BELLE TIRE- BUILDING IMPROVEMENTS JSP 15-23

Approval at the request of Enright Architects for approval of the Preliminary Site Plan and a Section 9 Façade Waiver. The subject property is located in Section 23, on Grand River Avenue, west of Meadowbrook Road, in the B-3, General Business District. This project consists of the replacement of virtually all façade material on the existing building and existing mansard roof material. The building improvements also include a new entry tower.

PLAN REVIEW CENTER REPORT

Planning Review

| SITE PLAN (Full plan set available for viewing at the Community Development Department.) | | | | | | | | |

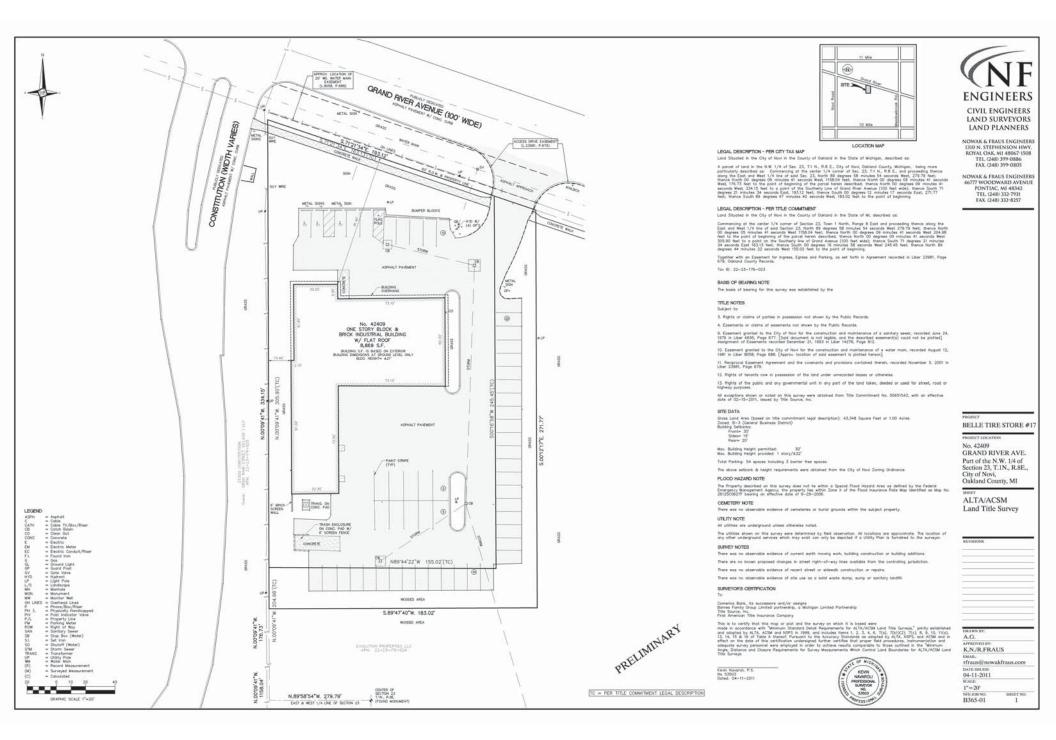
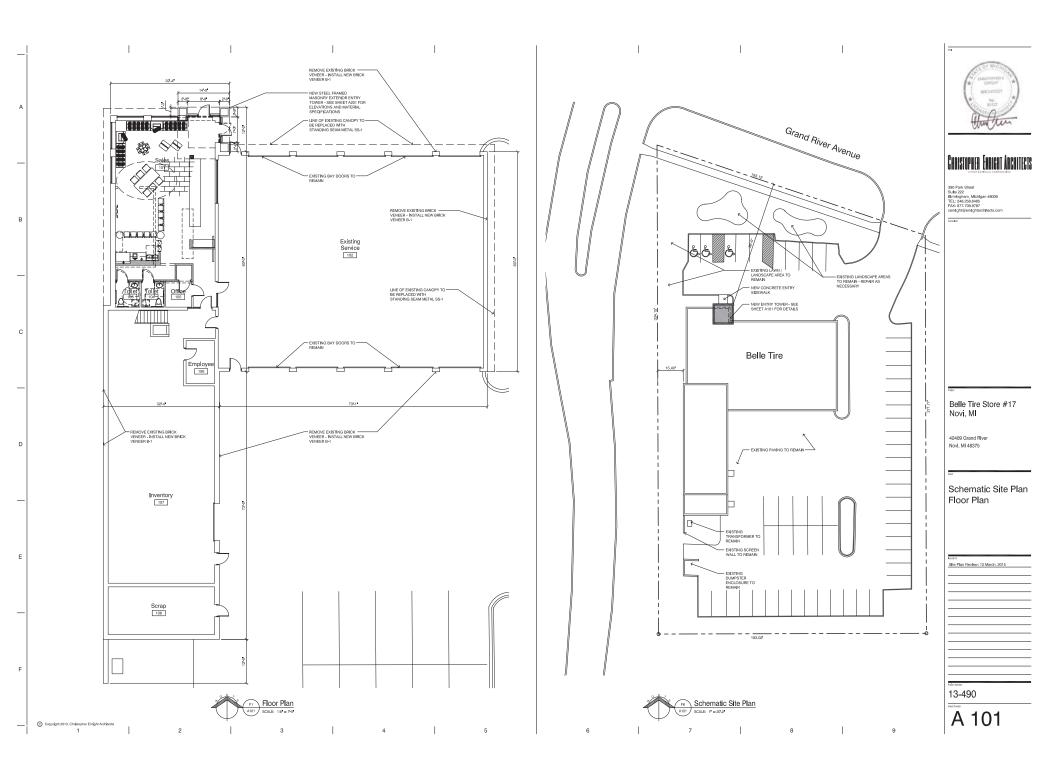
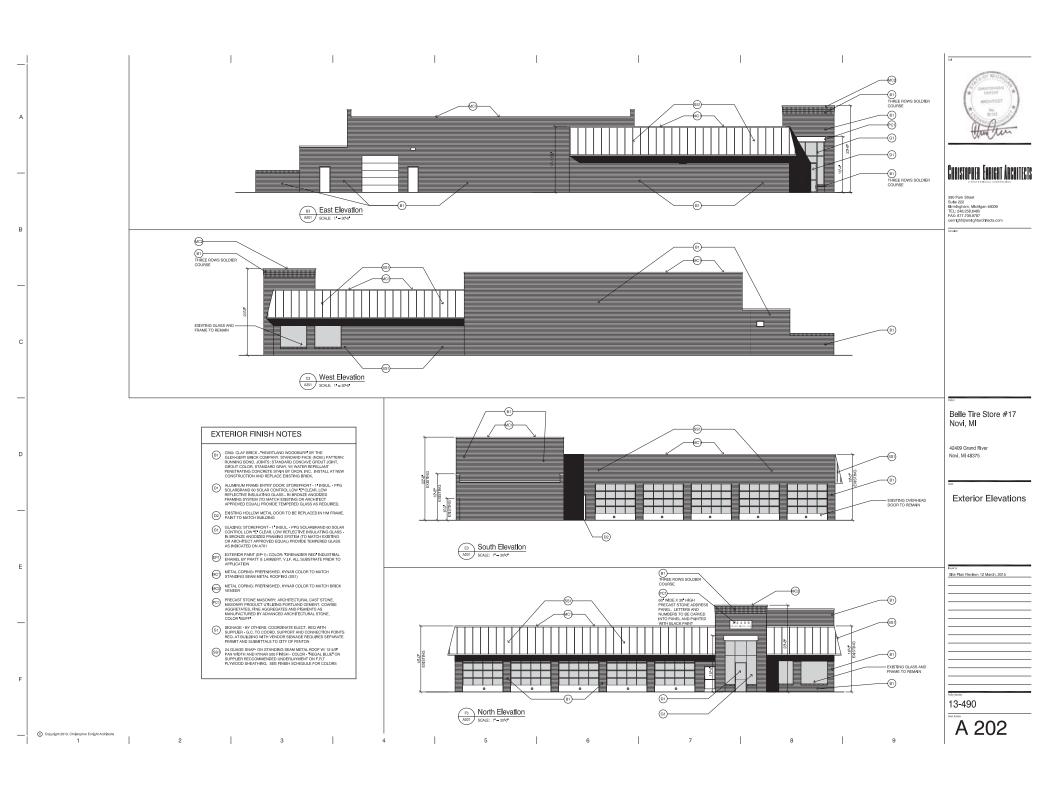
- 1. Sidewalk: Specify the width of the proposed sidewalk from the entry tower to the parking lot.
- 2. <u>Economic Impact Information</u>: Please provide the following in the response letter prior to Planning Commission Meeting.
 - Total cost of the proposed building & site improvements
 - Number of anticipated jobs created (during construction & after building is occupied, if known)

| | North (front) | South | East | West | Ordinance Maximum (Minimum) |
| Brick (existing) | 34% | 100% | 75% | 80% | 100% (30%) |
| Standing Seam Metal (existing, repainted) | 66% | 0% | 25% | 20% | 25% |

As shown above the percentage of Standing Seam Metal exceeds the maximum amount allowed by Façade Ordinance on the north facade. This project consists of the replacement of virtually all façade material on the existing building. This application has therefore been treated as a new structure with respect to the Façade Ordinance. The color sample board provided indicates that the "royal blue" color proposed for the standing seam roof is consistent with Section 15.5.2 regulating color.

Recommendation - The proposed modifications represent a significant enhancement to the overall aesthetic quality of the building. The deviation from the Ordinance is results from existing construction and does not detract for the appearance of the building. It is our recommendation the design is consistent with the intent and purpose of the Façade Ordinance and that a Section 9 Waiver be granted for the overage of Standing Seam Metal. The drawings show no roof equipment screening. It should be noted that all roof top equipment must be screened form all vantage points both on and off site with compliant materials.

- The proposed sidewalk width to the new north entry door is to be 6' wide and constructed of poured concrete.
- The total cost of all building improvements is anticipated to be approximately \$250,000.
- Total construction jobs created is anticipated to be approximately 10.
- Please see attached pdf files of drawings submitted.
- We can provide colored renderings to your office at a later date, but are not able to create them by today.
- All landscape requirements will be shown on the final site plan.
